# FINAL REPORT

## Independent Technical Audit of Los Alamos National Laboratory for Compliance with the Clean Air Act, 40 CFR 61, Subpart H in 2001

DOJ File Number: 90-5-1749A

October 2002

**Figure 1** November 2001 gamma dose rate at the NEWNET East Gate (new) station  
*Note: the 41  $\mu\text{R/hr}$  value on 11/28 was considered to be erroneous*

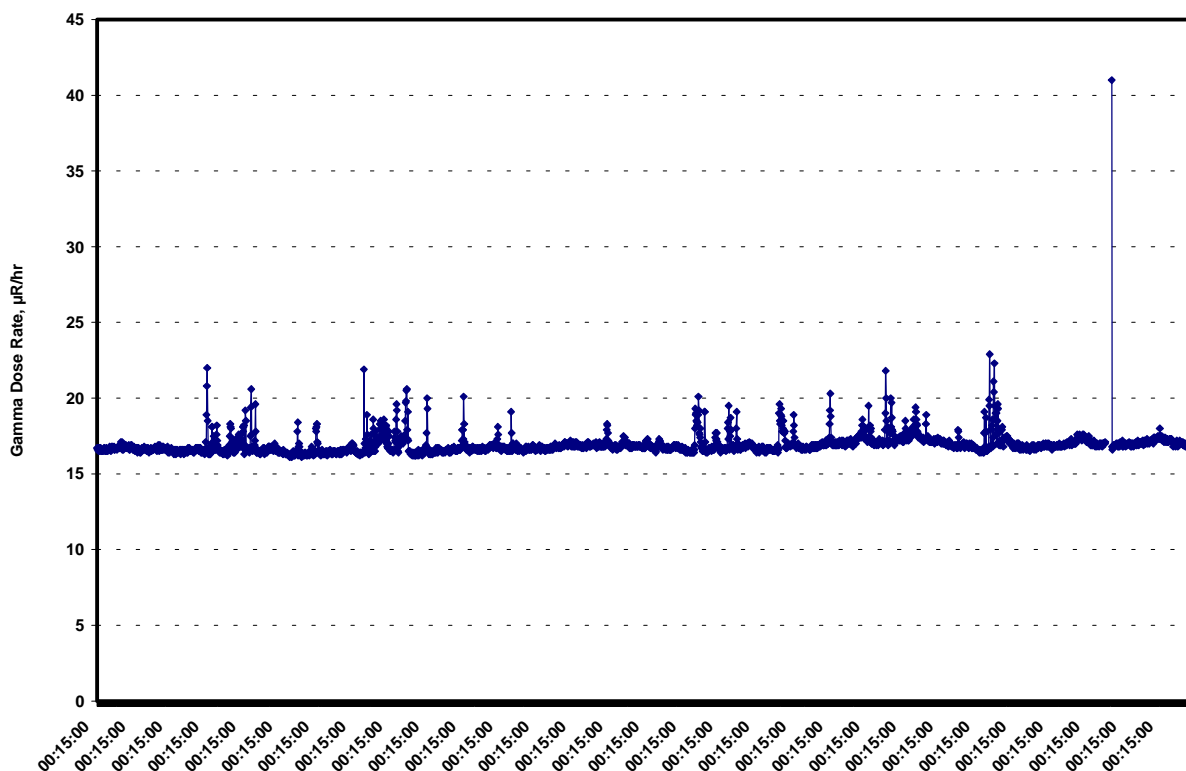
I present a somewhat different approach for the month of November 2001. Upon inspection of the gamma dose rate over time (Figure 1), a gradual shift is evident which may likely be due to instrument calibration.

**Figure 4** December 2001 gamma dose rate at the NEWNET East Gate (new) station as a function of wind direction in degrees

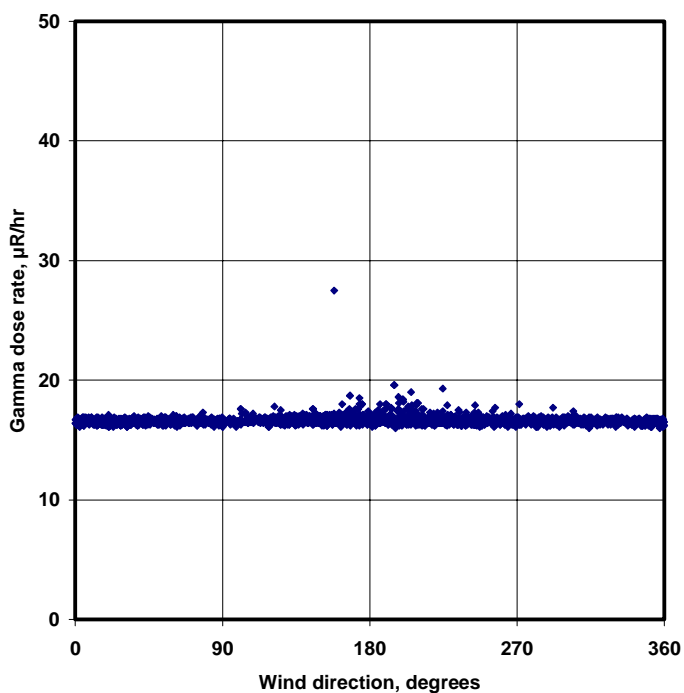
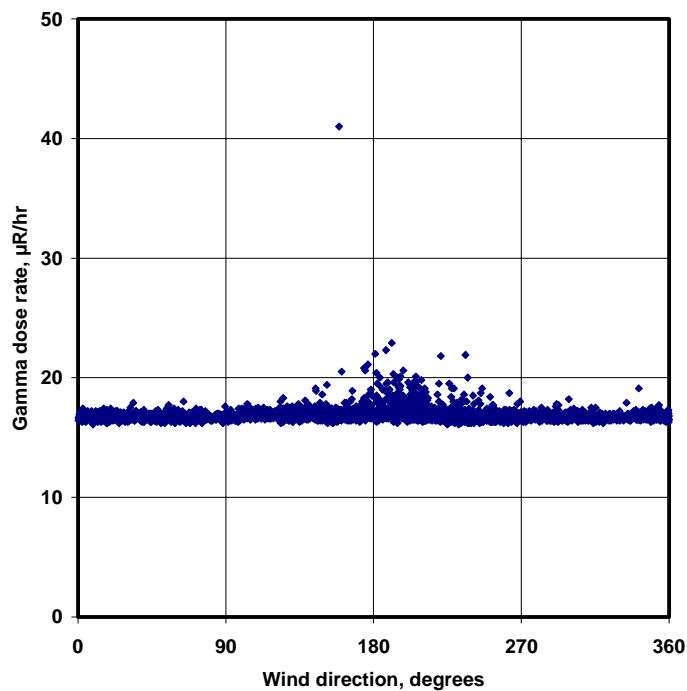
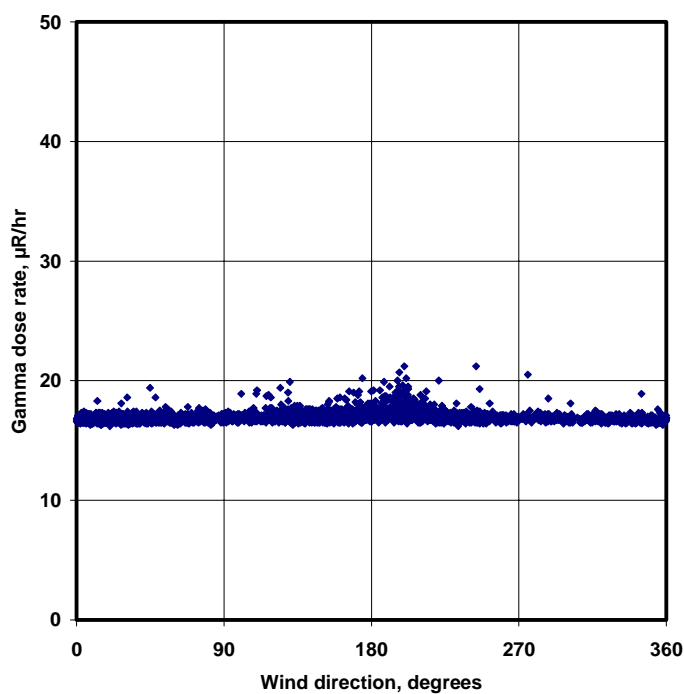
In addition, I would like to direct attention to the gamma dose rates as a function of the wind direction in the month December 2001 (Figure 4) compared to the data for October 2001 (Figure 2) and November 2001 (Figure 3). The increases in gamma dose rates at wind directions <90 and >270 degrees in the month of December 2001 are difficult to explain and may indicate electronic

noise at this station. That comes as a surprise because the station East Gate (new) was equipped with new data loggers that are supposed to have rectified the noise issue.

**Figure 1** Wind speed as a function of wind direction at East Gate NEWNET station, August 2002

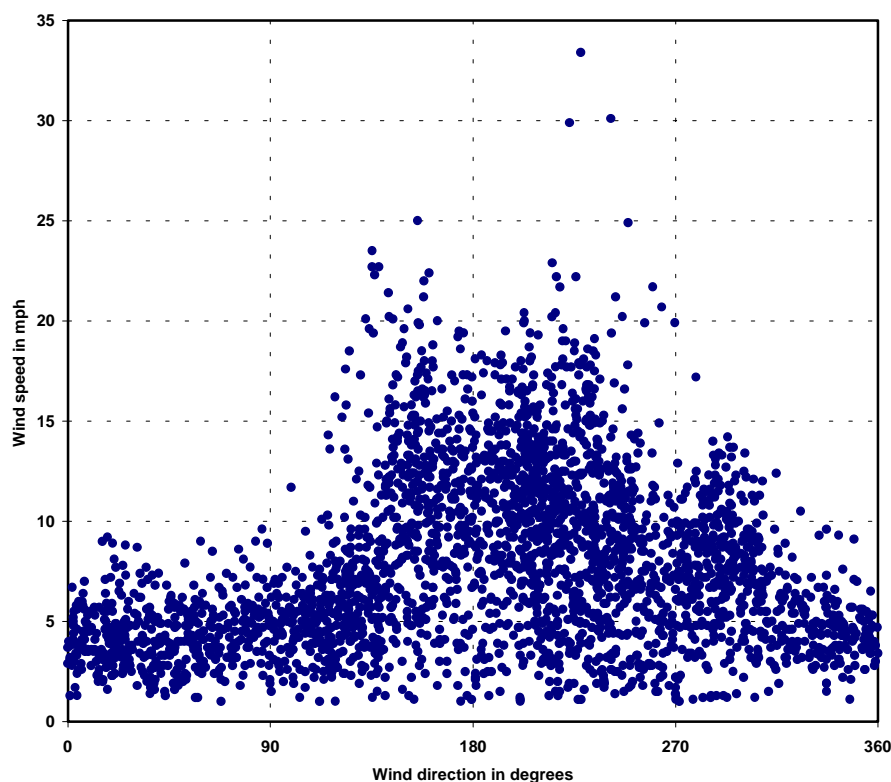
The underlying calculation assumes a steady-state release and is modelled with a simplified flat-terrain model. Both assumptions are not valid in this case. The use of a complex terrain model may lead to a different conclusion for a "TA-21 East" source. In addition, the releases from a diffuse source are most likely to occur during high wind speeds (>10 mph) when material can be readily suspended into air. High wind speed situations are more likely during wind blowing from the South/Southeast (see Figure 1).

With regard to diffuse sources at TA-21-East, the wind speed/direction pattern suggests that the greatest impact to residents from such a source is likely at the North Mesa residences.

**Figure 1.** Gamma dose rates in August 2002 at NEWNET stations Los Alamos High School, Espanola, and Ohkay Owingeh

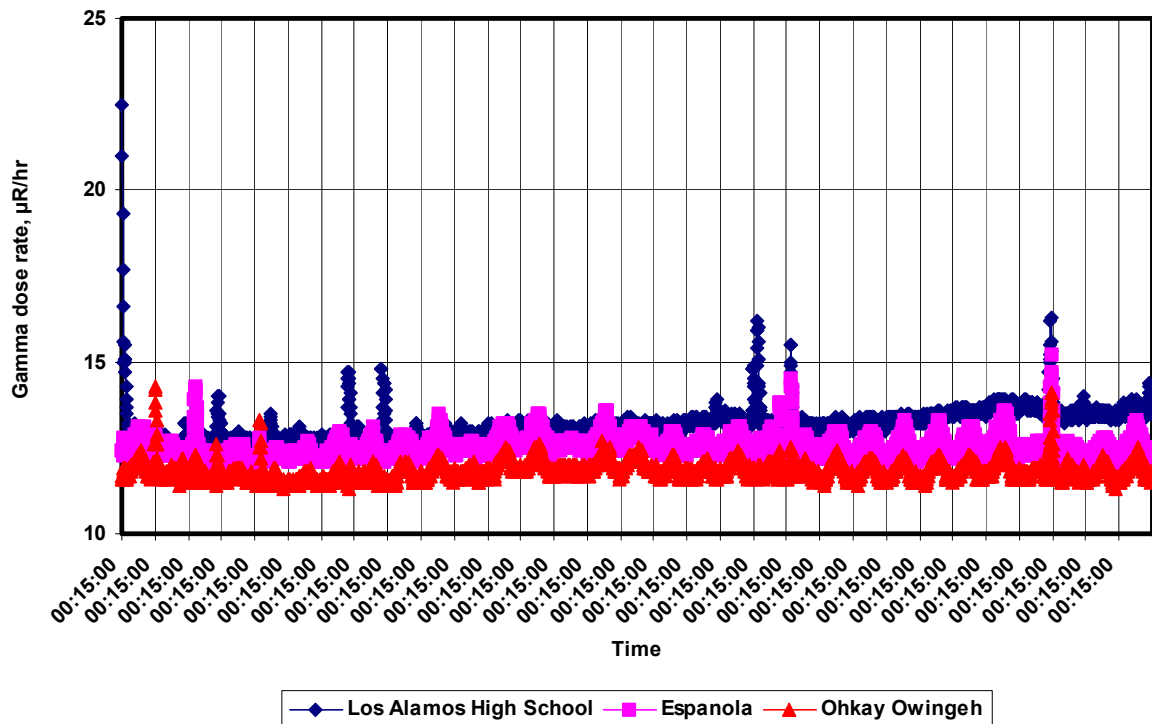
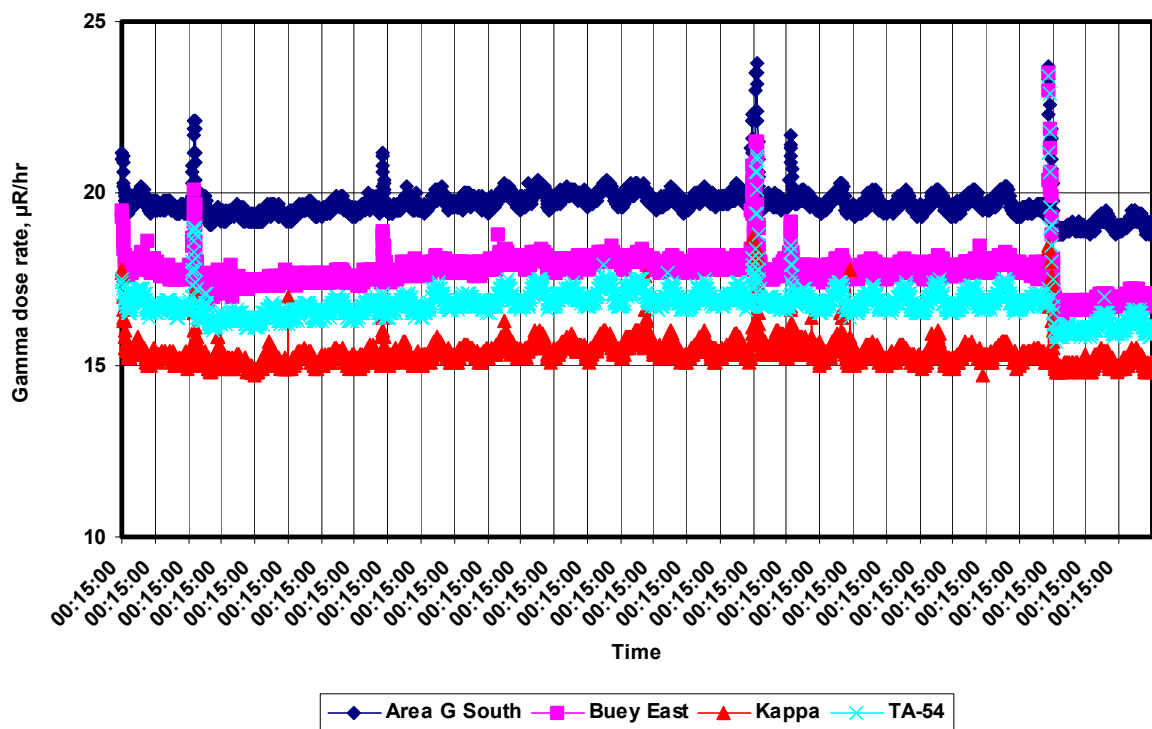
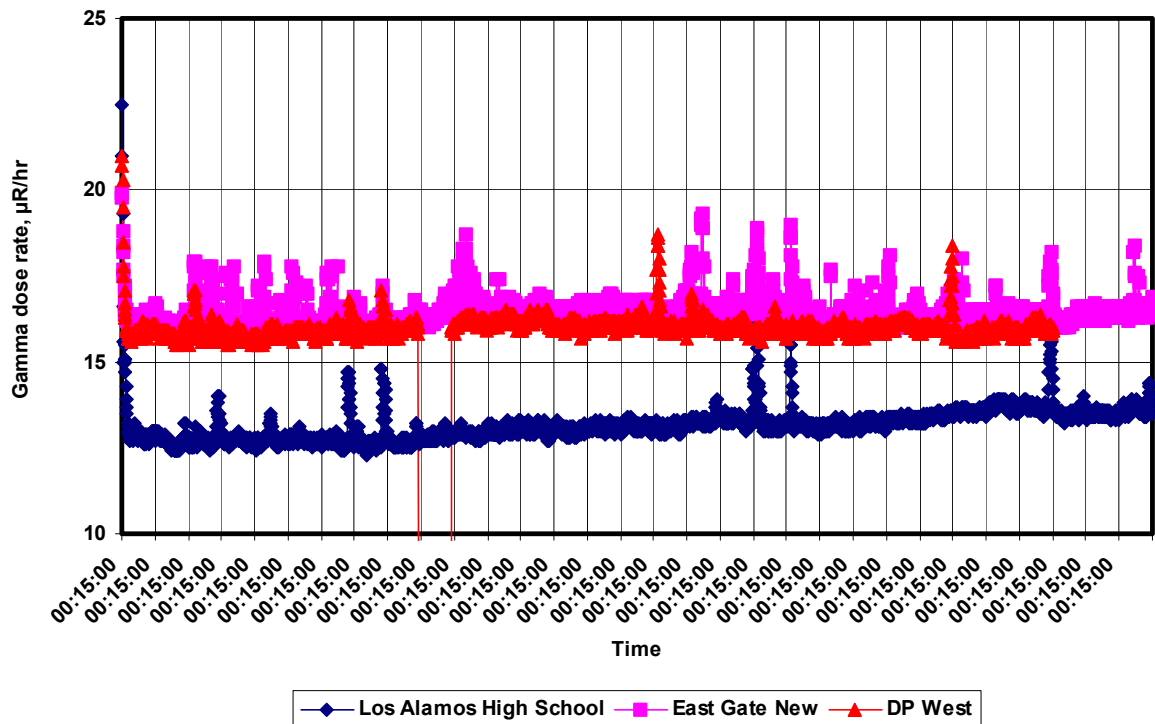
A better analysis is possible by plotting the data for selected close-by stations over time (Figures 1 to 3). An overview map indicating the location of LANL stations is given in Figure 4. The daily cycle in gamma dose rate is clearly visible. It is, however, missing for the "Los Alamos High School" station. Gamma dose rates increased significantly simultaneously which appears to be due to weather events. In this respect it is noteworthy that the station
